From: Countryman, Ryan
Sent: Monday, September 19, 2016 2:12 PM
To: Gary Huff (GHuff@karrtuttle.com) (GHuff@karrtuttle.com)
Cc: Kisielius, Laura; McCrary, Mike; Mock, Barb; Otten, Matthew; Rowe, Tom; 'Gary Huff'; 'Douglas A. Luetjen'; 'Steve Ohlenkamp'; 'Jack Molver'; dan.seng@perkinswill.com
Subject: Point Wells
Attachments: Point Wells Preliminary Draft EIS Preliminary Landslide Hazard Commentspdf

Thank you for the call this afternoon! I was drafting the email below to send in advance of our Tuesday meeting on Point Wells. The meeting purpose is to discuss timing and content of revisions to the project application relative to the publication of the Draft Environmental Impact Statement (DEIS). At the end of this email, I am appending an August 18 email that I sent to you as information for the others who are copied on this email. If, as seems likely following your call, we can quickly agree on the timing for revisions to the project applications, then we could spend the bulk of our meeting time tomorrow prioritizing issues for the content of revisions to the application.

Image 1: Landslide Hazard Issues

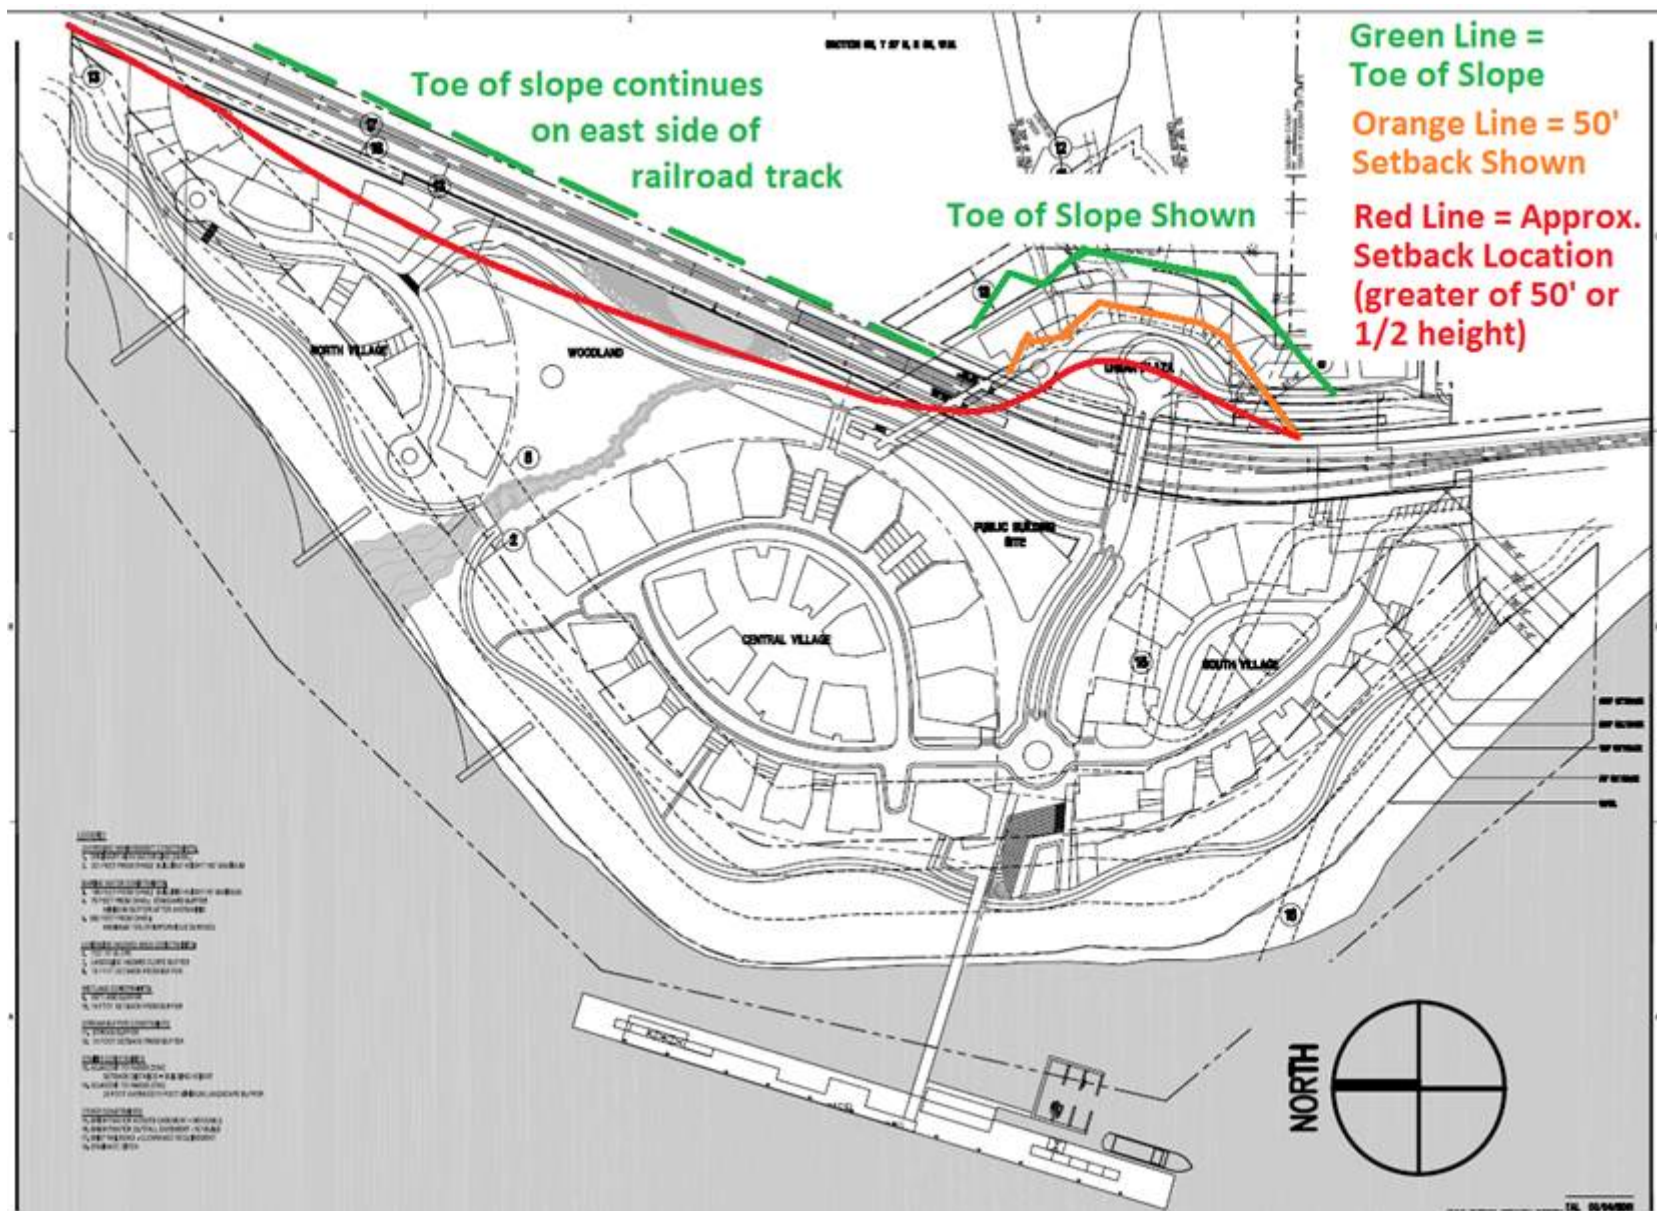
The site plan, geotechnical reports and other documents only discuss landslide hazards in the portion of the site east of the railroad tracks. Image 1 below is adapted from Sheet A-051 and illustrates where a second landslide hazard to the north village is entirely omitted in the application and other materials provided by the applicant. This issue alone would require an SEIS, see attached comments to the preliminary draft EIS. Snohomish County needs this to be part of the EIS review so that we can recommend steps to mitigate landslide risks to buildings and the parking garage in the North Village. Similarly the landslide setbacks shown on the phase east of the tracks do not represent the effective code requirements; thereby rendering insufficient the recommendations that would be based on the setbacks shown.

On page 9 of an [April 12, 2013, Review Completion Letter](#) by my predecessor, Darryl Eastin, it was noted that, the "site development plans do not depict the location and description of all other critical areas regulated pursuant to Chapters 30.62B" [Geologically Hazardous Areas] which is the issue above.

Image 2: Impervious Surface Issues

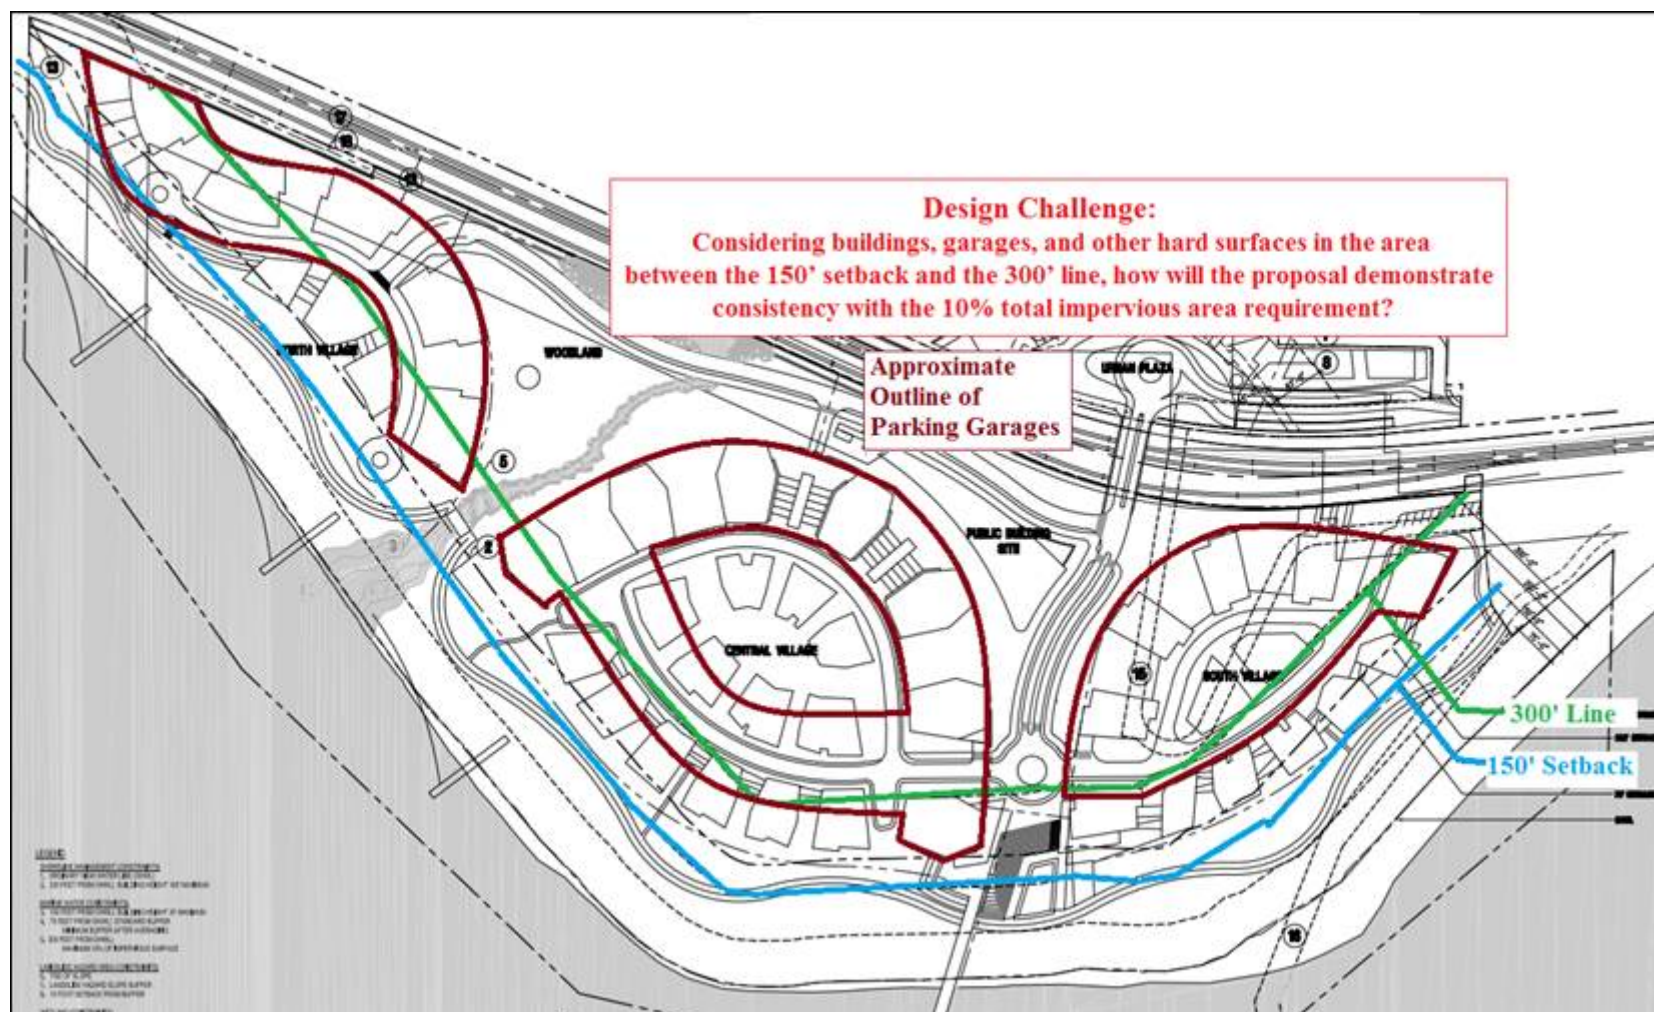
The 2013 letter also asks for "clarification of how the project meets the provisions of SCC 30.62A.320(1)(c) regarding impervious surfaces within buffers" from Puget Sound. We are still waiting for this clarification and have created Image 2 (below) to help illustrate the concern. (Image 2 is also adapted from Sheet A-051). The August

18, 2016, email included at the bottom of this email refers to specific steps that the applicant could take to lessen the design challenge of staying below impervious surface maximums.

Even with the steps that we identified as possibilities for your client to consider, the recommendation in the 2013 letter that “Staff suggests that the applicant make a request for review under the innovative development design provisions of SCC 30.62A.350” stands. Without use by the applicant of the Innovative Development Design [IDD] provisions, we cannot approve the site plan. Even with IDD, it is likely that the amount of impervious surface near Puget Sound will need to be less. Absence of an approved IDD plan means that the DEIS must disclose that the application does not comply with Snohomish County Requirements to protect Wetlands and Fish & Wildlife Habitat Conservation Areas (Chapter 30.62A SCC). We cannot simply recommend conditions of approval on this subject to the Hearing Examiner and expect a favorable decision on the project. Therefore, the applicant must make some changes before the project goes to hearing. These changes may significantly alter the size or design of the project. (Please note that IDD is only part of what it would take to meet code requirements.)
